SAND CREEK VIEW

CITY OF COON RAPIDS COUNTY OF ANOKA

SURVEYORS CERTIFICATION OF CORRECTION TO THE PLAT OF SAND CREEK VIEW 678276

SAND CREEK VIEW

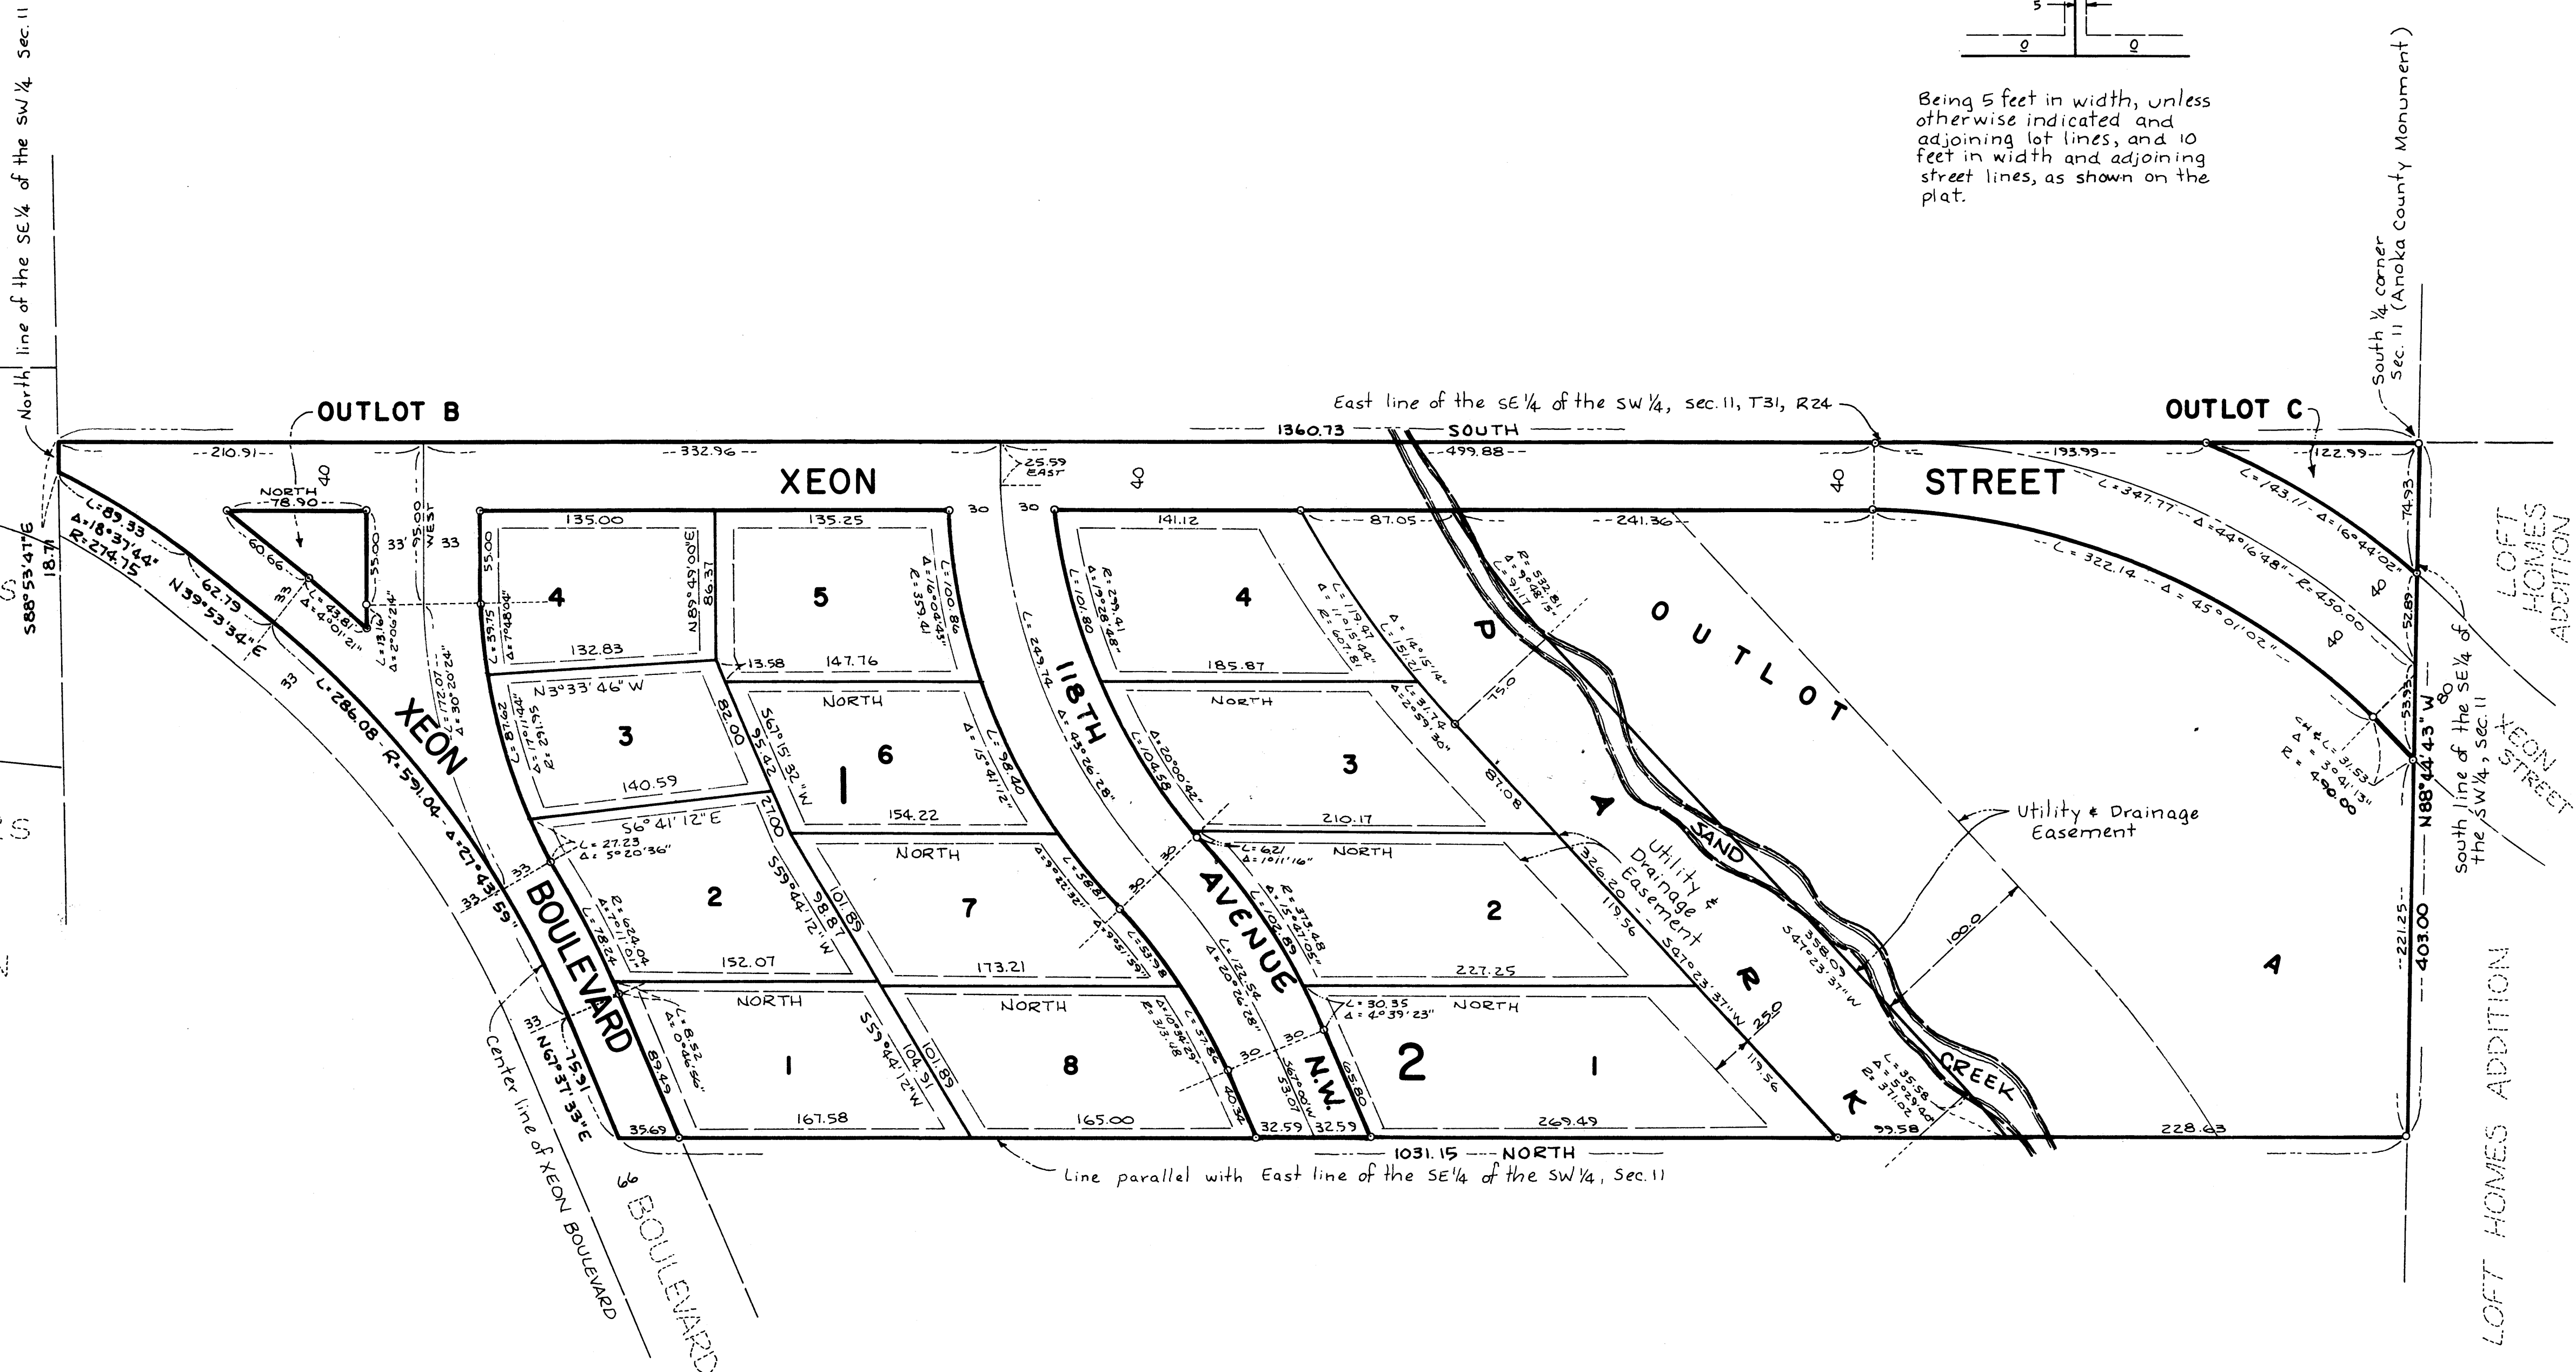
- I hereby certify that the said plat contains errors in the following particulars to-wit:
1. The distance along the south boundary of the plat shows 403.00 feet.

2. The distance along the south boundary of Outlet A shows 221.25 feet.
 3. The distance along the southeasterly line of the Park shows 35.58 feet and a central angle of 5 degrees 29 minutes 40 seconds.

4. The distance along the southerly line of Lot 1, Block 2, shows 119.56 feet.
 5. The distance along the northerly line of Lot 1, Block 2, shows 65.89 feet.

6. The distance along the southerly line of Lot 8, Block 1, shows 40.34 feet.
 7. The distance along the northerly line of Lot 8, Block 1, shows 101.89 feet.

8. The distance along the southerly line of Lot 1, Block 1, shows 104.91 feet.
 9. The distance along the northerly line of Lot 1, Block 1, shows 89.49 feet.

10. The distance along the northerly boundary of the plat shows 75.91 feet.
 11. The distance along the west line of Outlet A shows 228.63 feet.
 12. The distance along the west line of the Park shows 99.58 feet.

13. The distance along the west line of Lot 1, Block 2 shows 269.49 feet.
 14. The distance along the west line of Lot 8, Block 1, shows 165.00 feet.
 15. The distance along the west line of Lot 1, Block 1, shows 167.58 feet.

- The said plat is hereby corrected in the following particulars to-wit:
1. The distance along the south boundary of the plat should show 403.00 feet.
 2. The distance along the south boundary of Outlet A should show 221.25 feet.

3. The distance along the southeasterly line of the Park should show 35.71 feet and a central angle of 5 degrees 30 minutes 50 seconds.
 4. The distance along the southerly line of Lot 1, Block 2 should show 119.70 feet.

5. The distance along the northerly line of Lot 1, Block 2, should show 65.91 feet.
 6. The distance along the southerly line of Lot 8, Block 1, should show 40.44 feet.

7. The distance along the northerly line of Lot 8, Block 1, should show 102.01 feet.
 8. The distance along the southerly line of Lot 1, Block 1, should show 105.03 feet.

9. The distance along the northerly line of Lot 1, Block 1, should show 89.60 feet.
 10. The distance along the northerly boundary of the plat should show 76.02 feet.

11. The distance along the west line of Outlet A should show 228.55 feet.
 12. The distance along the west line of the Park should show 99.57 feet.
 13. The distance along the west line of Lot 1, Block 2 should show 269.54 feet.

14. The distance along the west line of Lot 8, Block 1, should show 164.98 feet.
 15. The distance along the west line of Lot 1, Block 1, should show 167.50 feet.
